Scan Technologies, Inc.

RE: SS&D Certificate NR-0716-D-110-S Amendment

This letter is in response to your questions dated June 12, 2015, regarding our amendment to add a new sealed source model to Registration Certificate NR-0716-D-110-S.

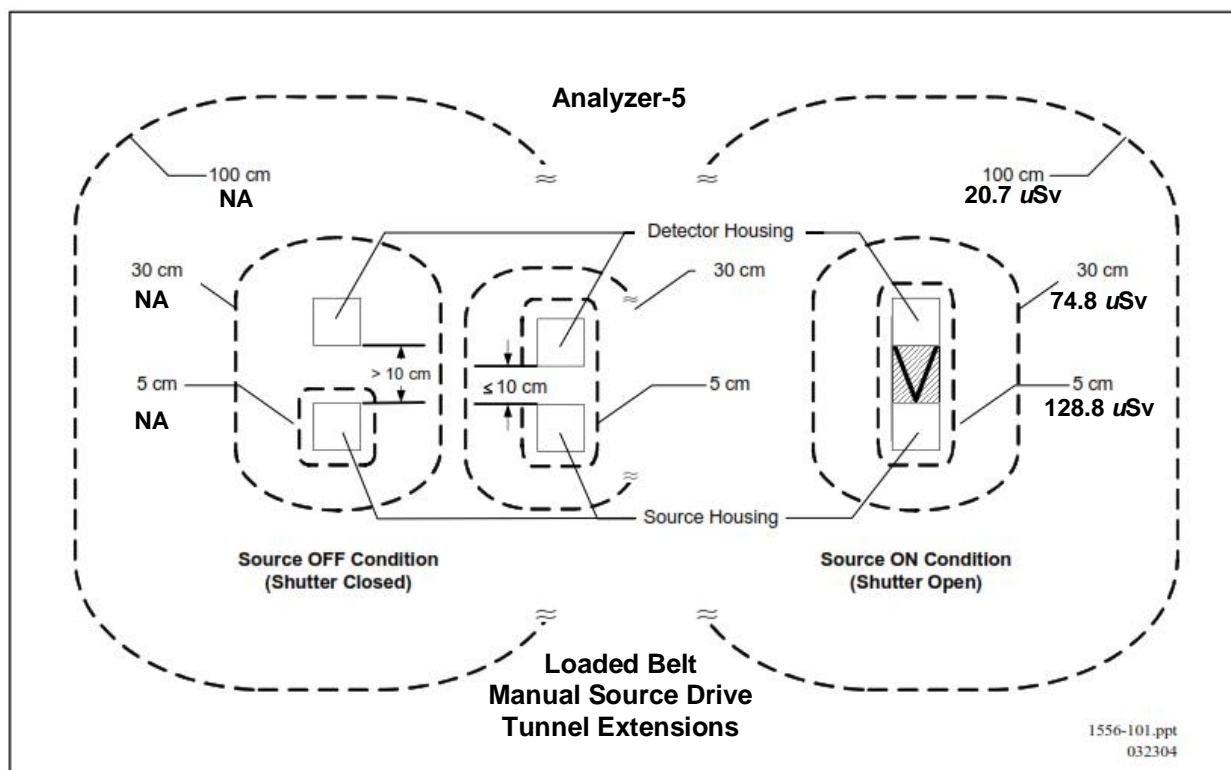
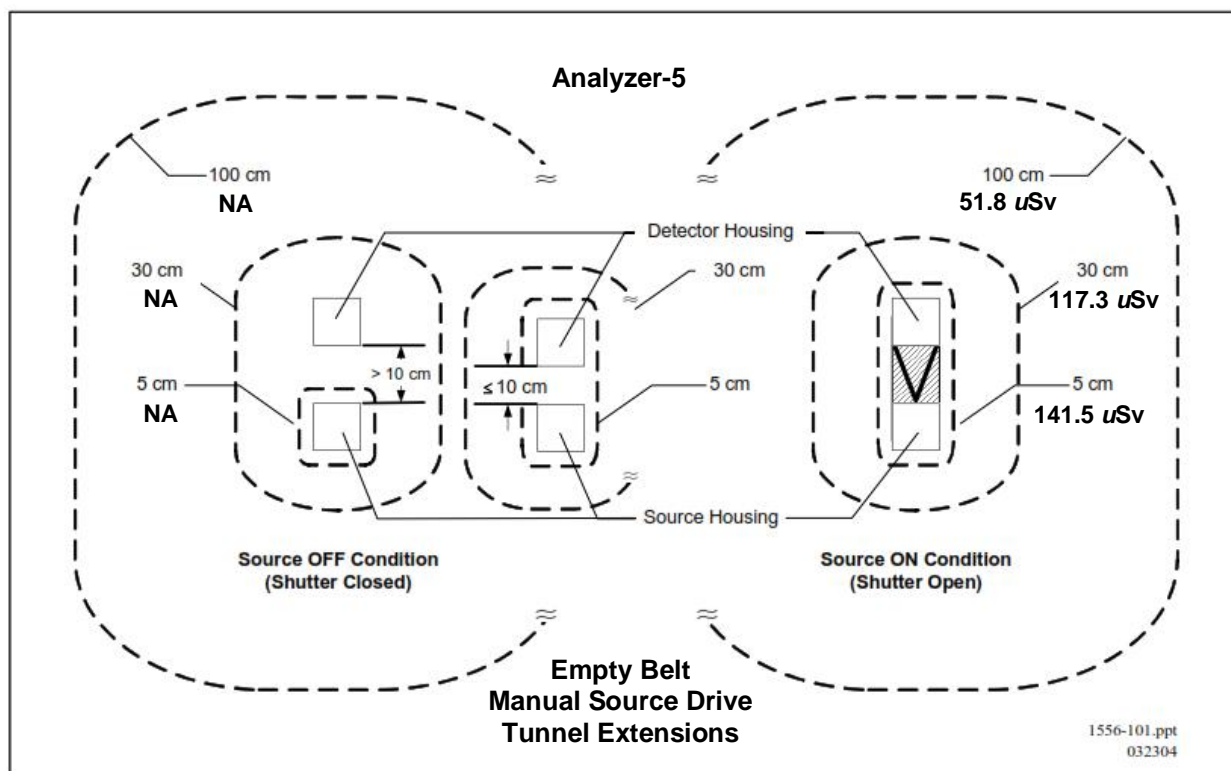
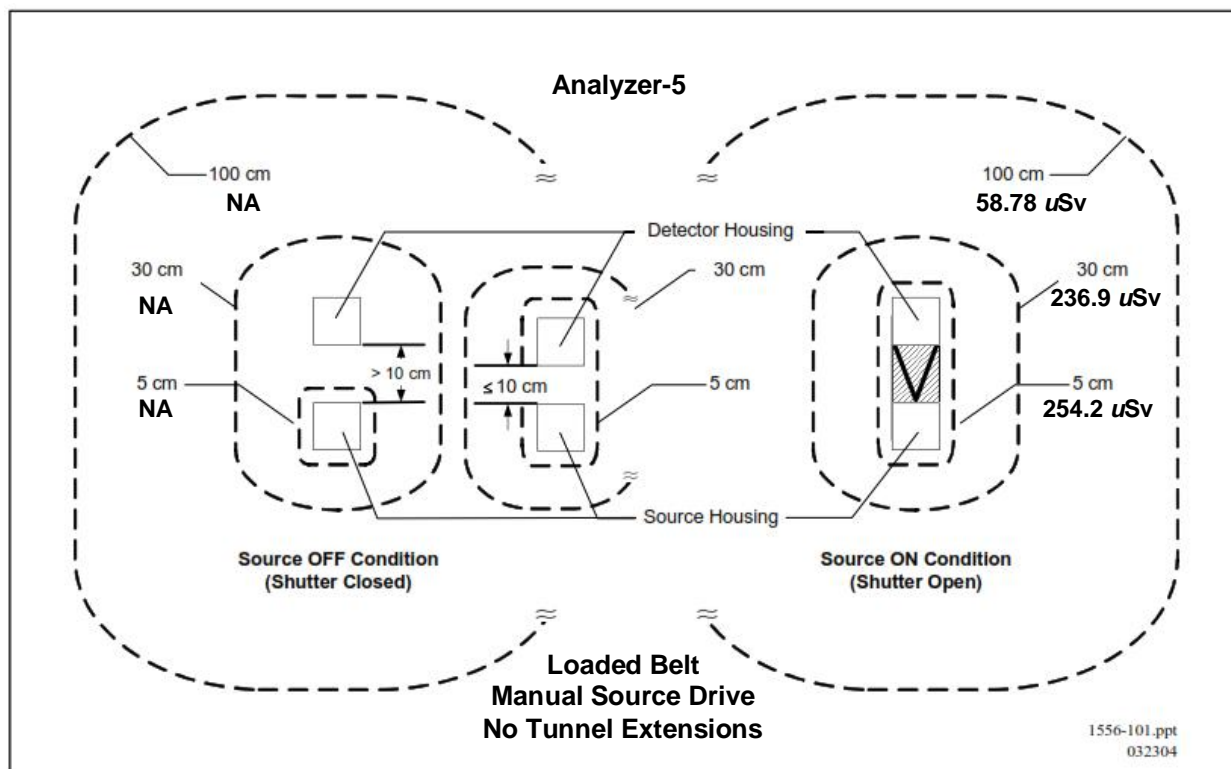
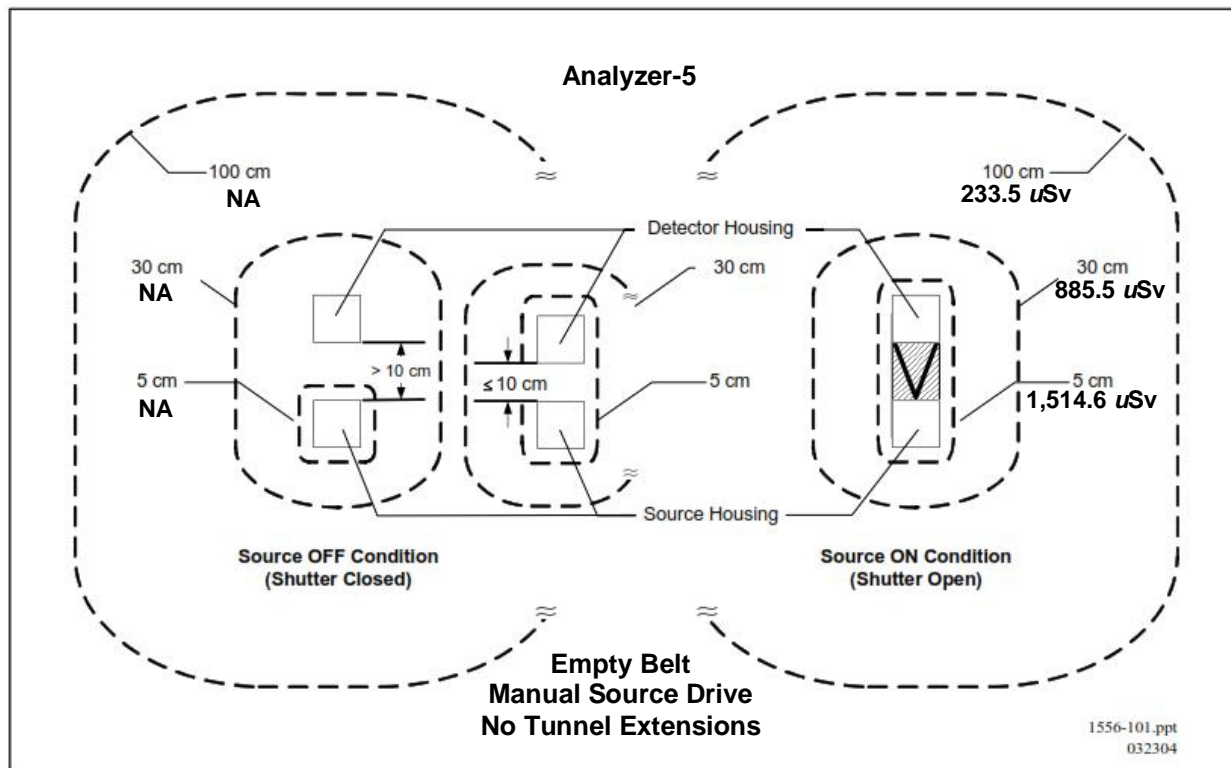
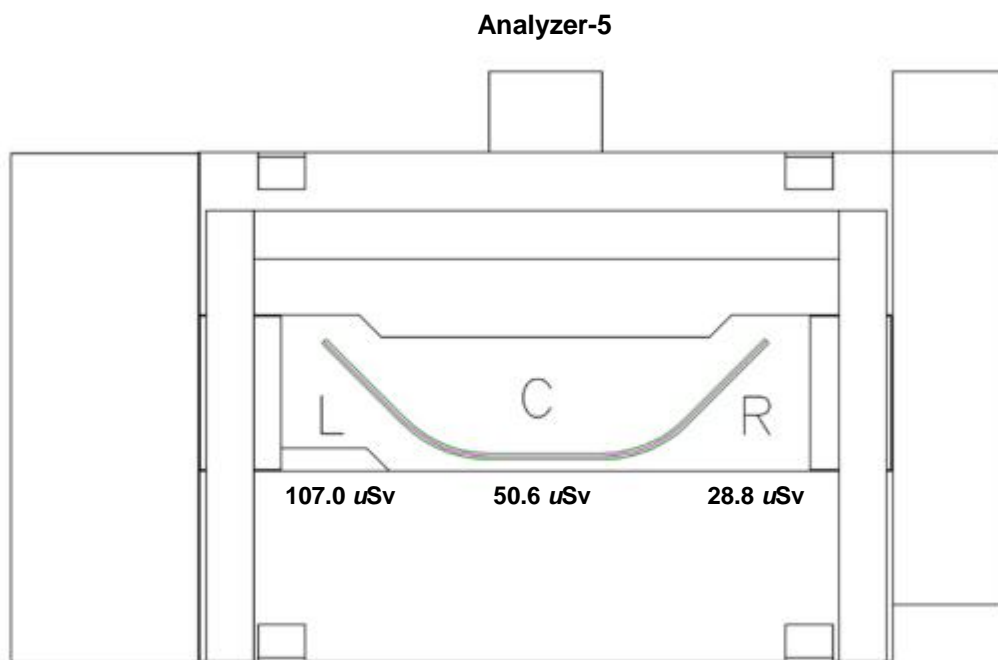
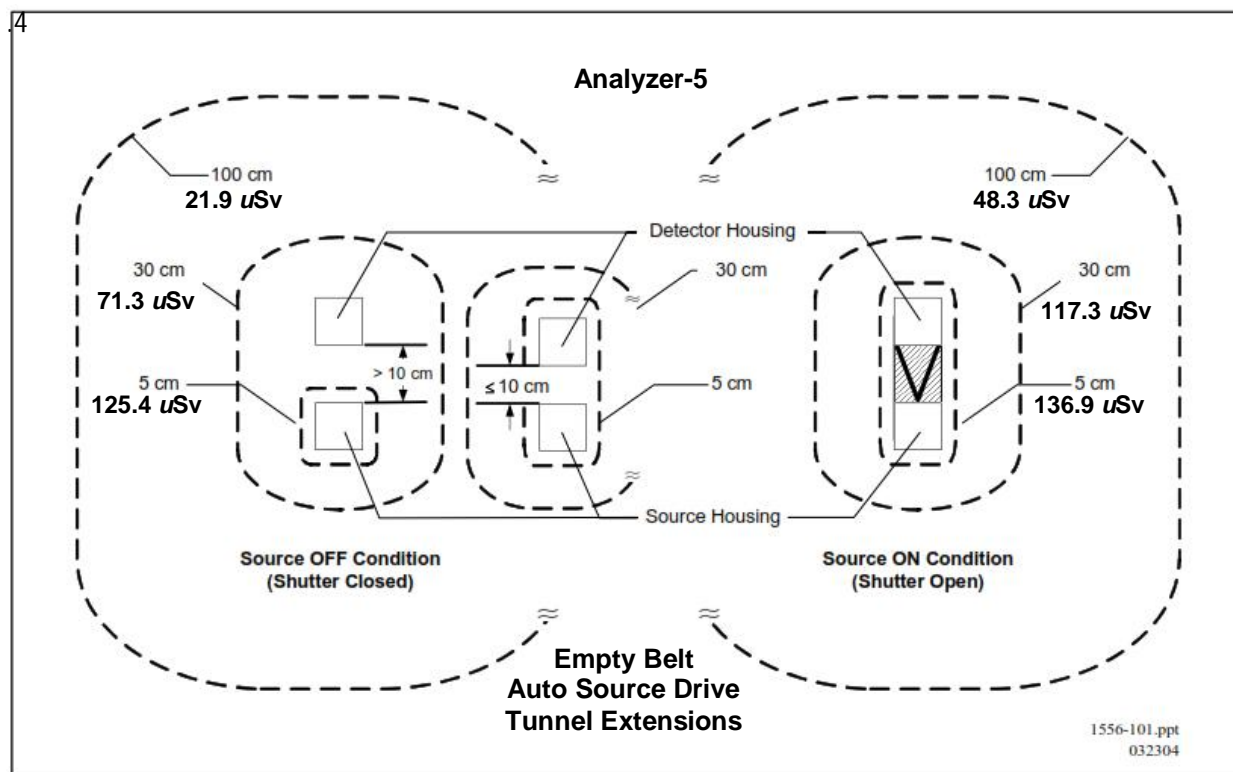
2. Please confirm that the Cf2.N02 sources will not exceed the maximum activity of 50 μg (26.8 mCi) of Cf-252 that is currently stated in the device registration certificate.

3. Please discuss whether there are any changes to the radiation profiles (external radiation levels) for the Analyzer-5 and Analyzer-6 device models, based on the Cf2.N02 source model. Also, if the source is expected to contain a maximum activity of 57.5 μg of Cf-252 at any time, please provide the radiation profiles.

The Cf2.N02 sources will not exceed the maximum nominal activity of 50 μg (26.8 mCi) that is currently stated in the device registration certificate. However, the manufacturer states that there is the potential for a +15% actual activity tolerance. Therefore, the actual source activity could be as high as 57.5 μg , or 30.8 mCi and still be sold as a 50 μg source. Typically, there would be a 2-3 month delay between manufacture and installation, so the source would be decayed to approximately 54 μg , but we will proceed under the assumption that the source could arrive and be installed at the maximum 57.5 μg activity level.

For this case and all situations where the actual source activity might be larger than the nominal activity of the source, we are submitting a new set of radiation profiles showing the radiation levels around the gauge based on a maximum activity level of 57.5 μg . We have prepared these radiation patterns for the Analyzer-5, Analyzer-6, and the storage drum.

There should not be any changes to the radiation profiles based on the use of the Cf2.N02 source model versus the originally licensed sources. The source will be installed into the same source holder and source rod as the original sources and will have a similar radiation profile. The only significant difference would be the intensity of the dose profiles due to higher or lower actual source activities.

The following radiation profiles represent the maximum radiation levels around the Analyzer using a nominal 50 μg Cf-252 source that has a +15% tolerance, or an actual activity of 57.5 μg . The radiation measurements can be found in the attachments.
